Seismic Walkdown Checklist (SWC)

Equipment ID No. 1-1808-Q3-L47 Equip. Class¹² 14 (DISTRIBUTION PANELS & AUTOMATIC TRANSFER SWITCHES)
 Equipment Description EMERGENCY LTG DIST PANEL IN LPA7
 Location: Bldg. DG Floor El. 220' Room, Area R101
 Manufacturer, Model, Etc. (optional but recommended) _____

Equipment ID No. 1-1816-U3-017 Equip. Class¹² 20

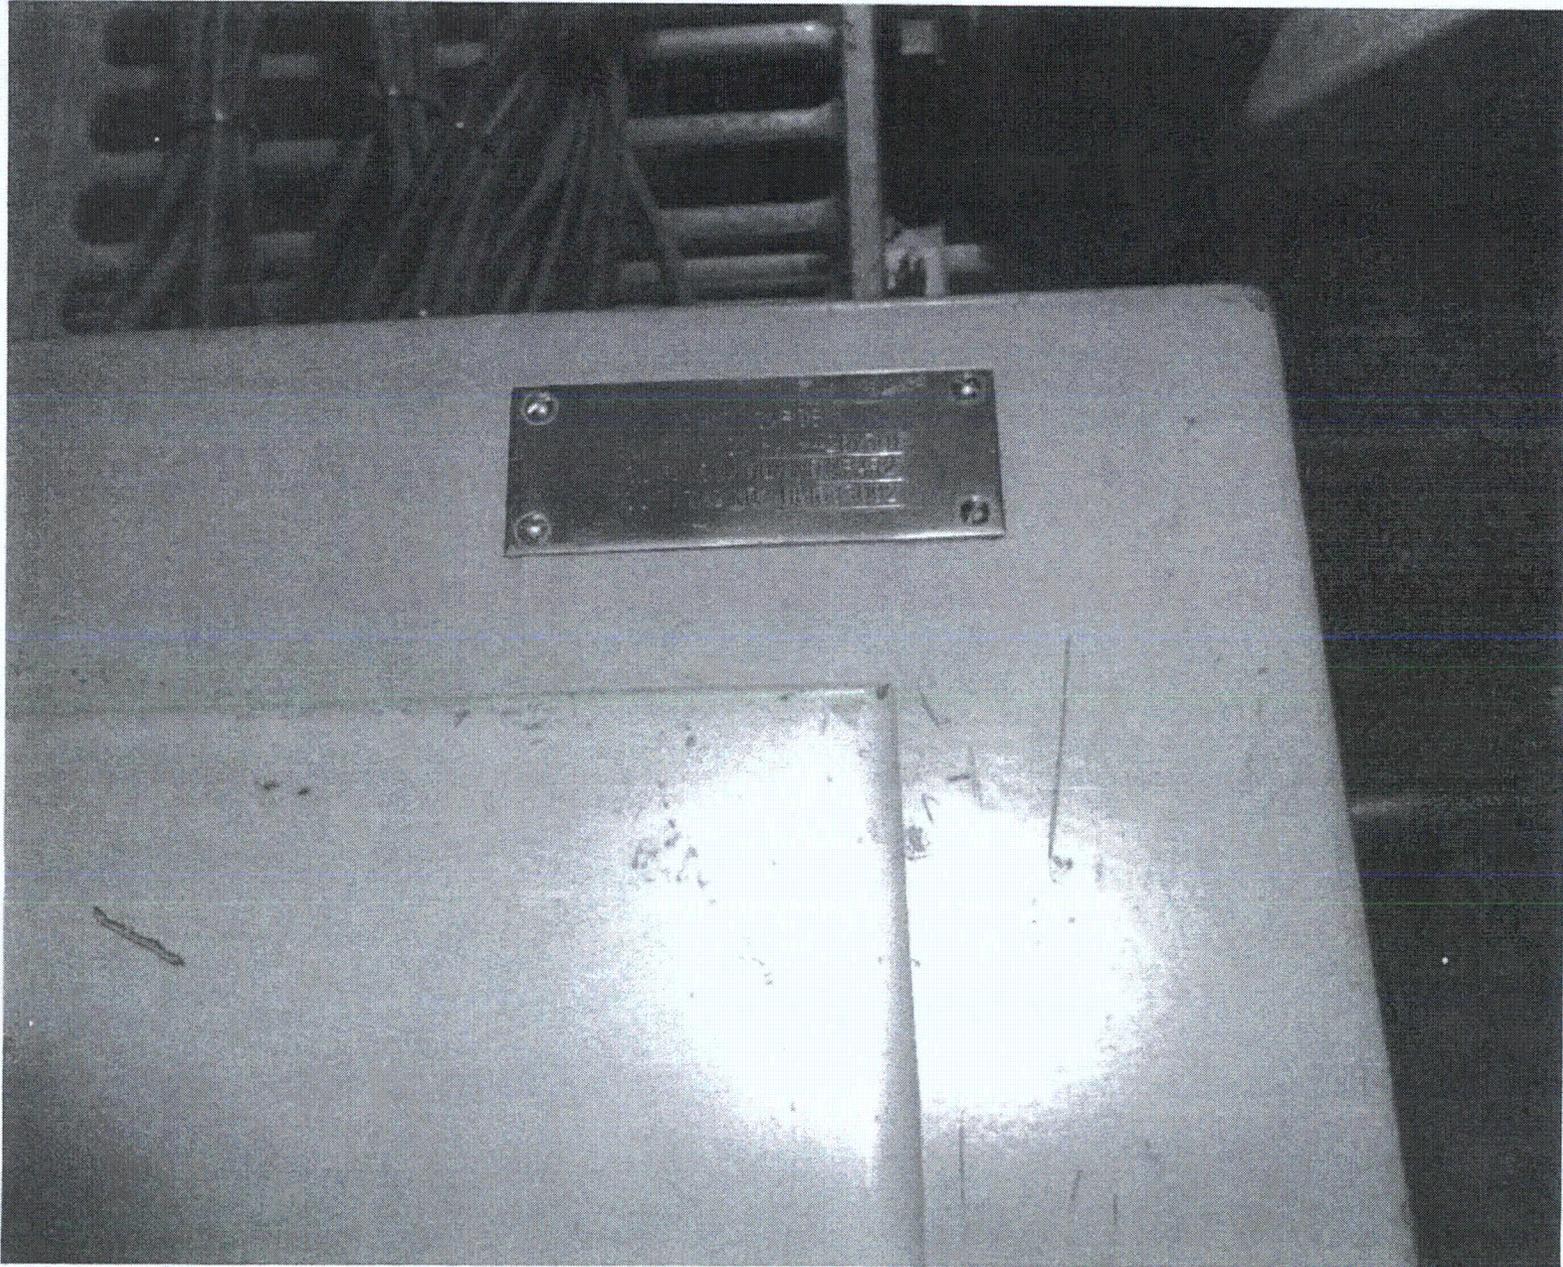
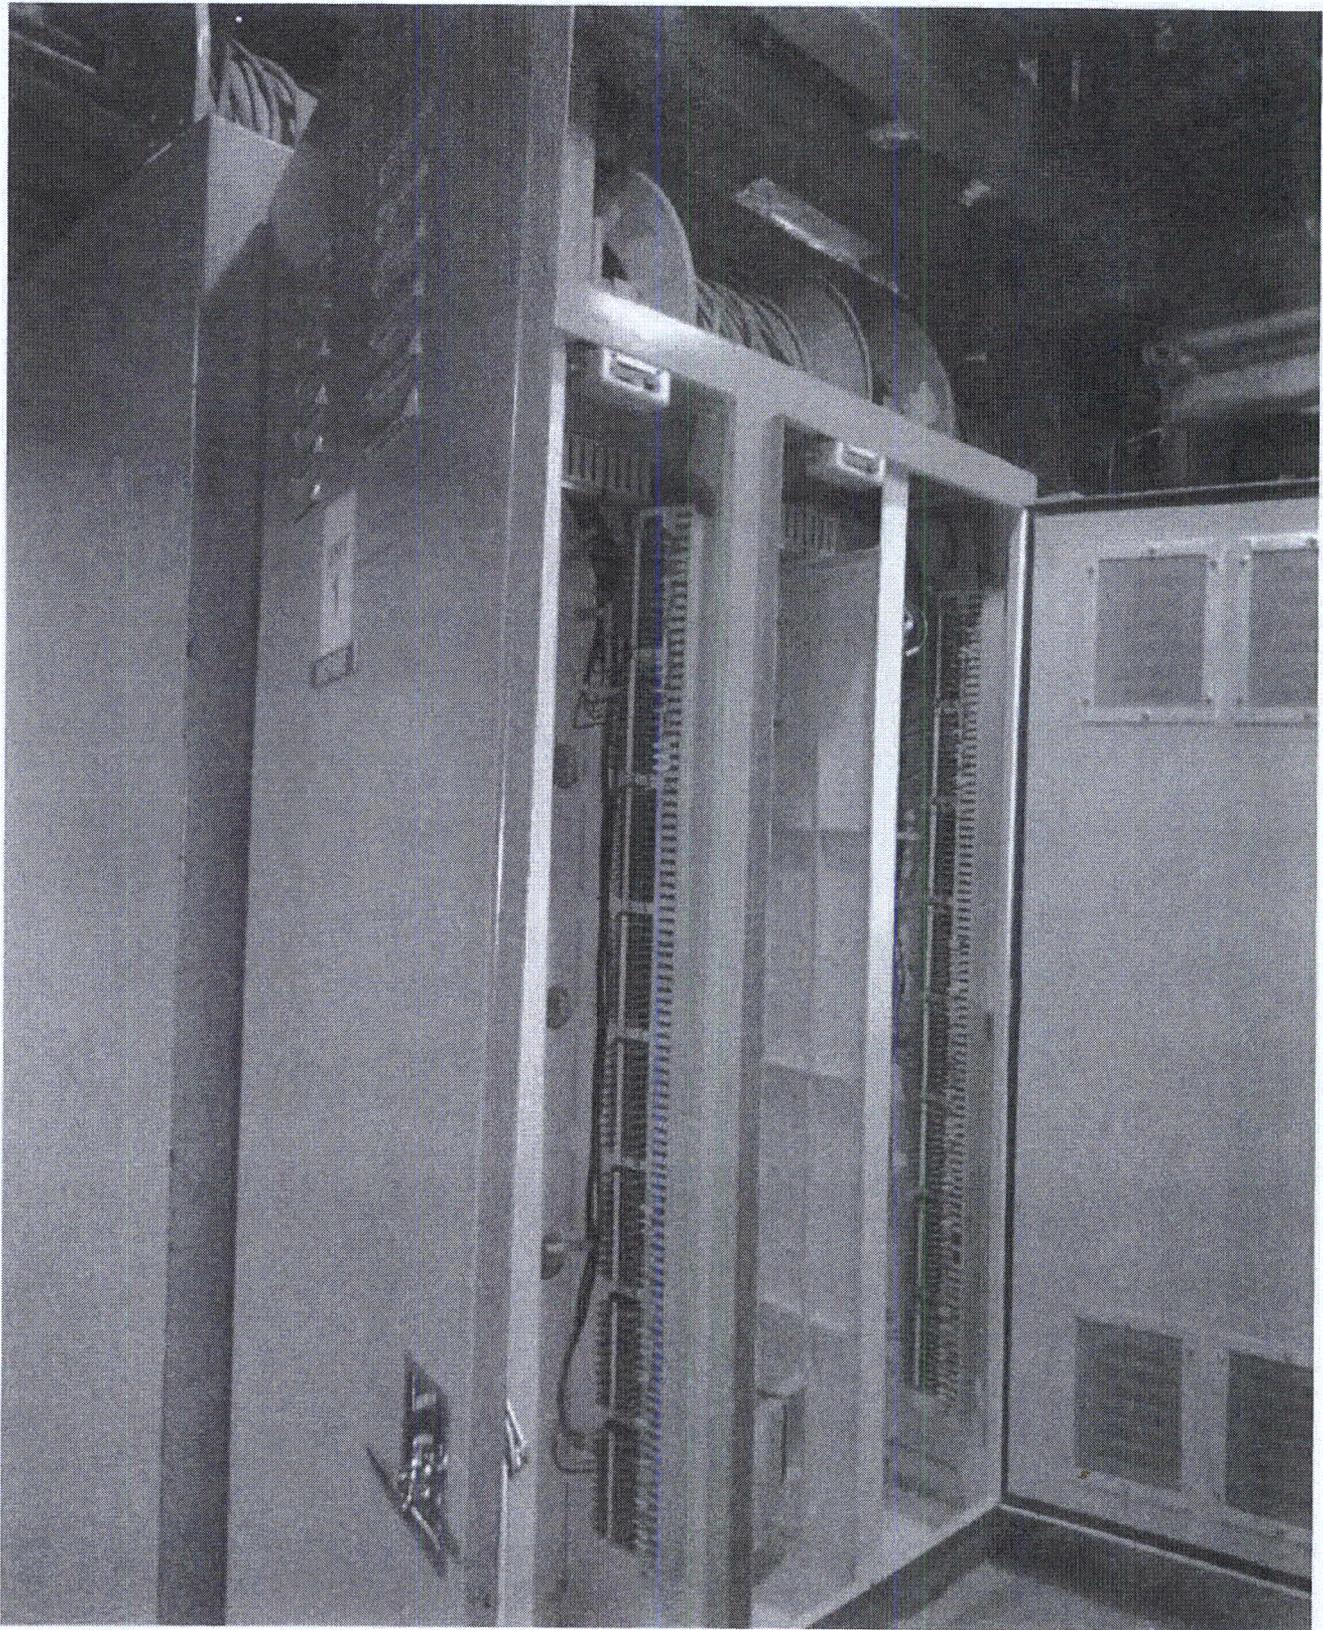
11. Have you looked for and found no other seismic conditions that could adversely affect the safety functions of the equipment? Y N U
A visual inspection of the internal components of this cabinet was performed to check for seismic adequacy to include any evidence of internal components not adequately secured, checked to ensure fasteners connecting adjacent cabinets were in place, and evidence of other adverse seismic conditions. No significant adverse conditions were found. Some minor issues found are documented in the "Comments" section.

- Found screws missing used to secure terminal blocks and to secure a door alarm inside the cabinet. It was judged that this condition does not represent a seismic vulnerability or concern. Reference condition report 527701

Equipment ID No. 1-1821-U₂-002 Equip. Class¹² Z0
 Equipment Description 5F Sequencer Board Train B
 Location: Bldg. CB Floor El. 200'-0" Room, Area RASO
 Manufacturer, Model, Etc. (optional but recommended) _____

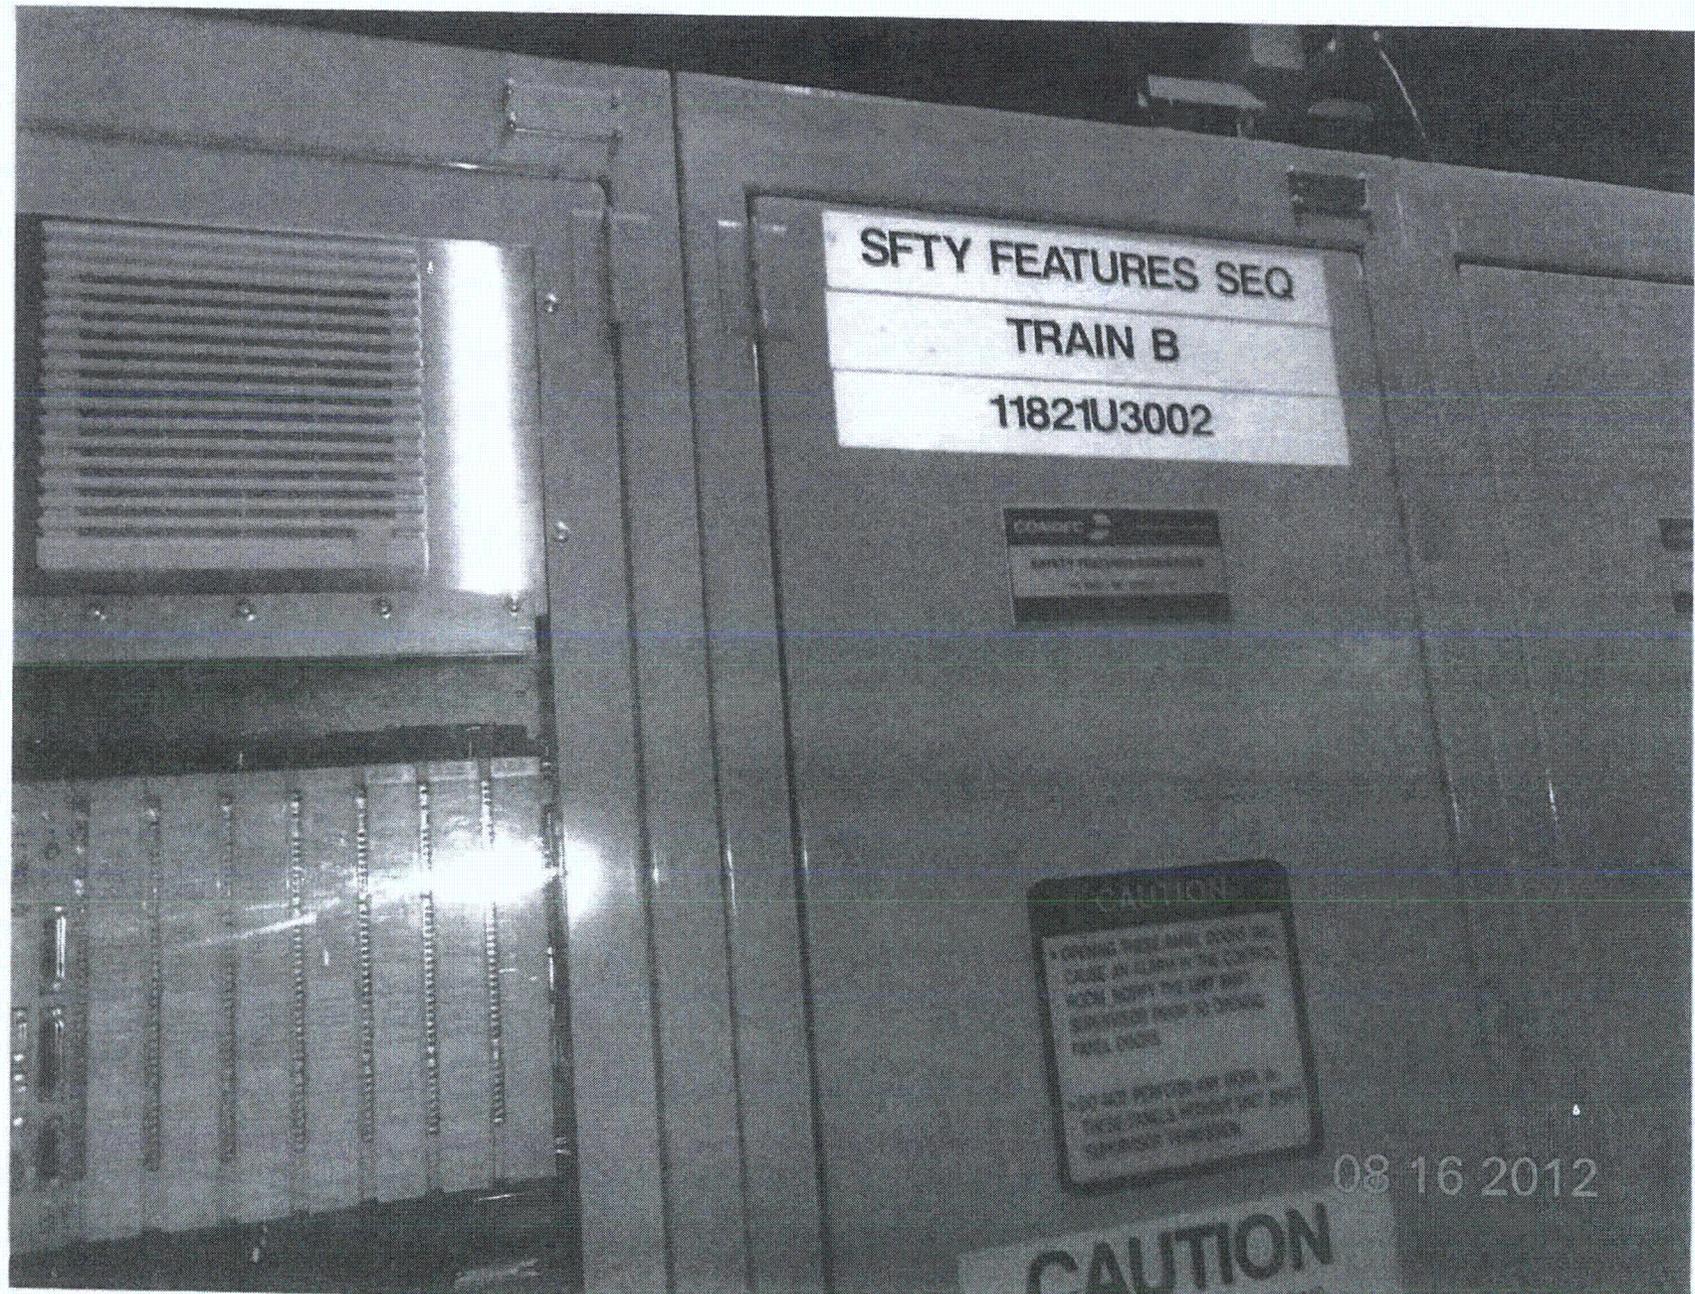
2. Is the anchorage free of bent, broken, missing or loose hardware? Y N U N/A
Panels are welded to embed plates.

3. Is the anchorage free of corrosion that is more than mild surface oxidation? Y N U N/A
panels are welded to emb plate. Welds have no cracks.

4. Is the anchorage free of visible cracks in the concrete near the anchors? Y N U N/A
concrete is in good condition near welds.
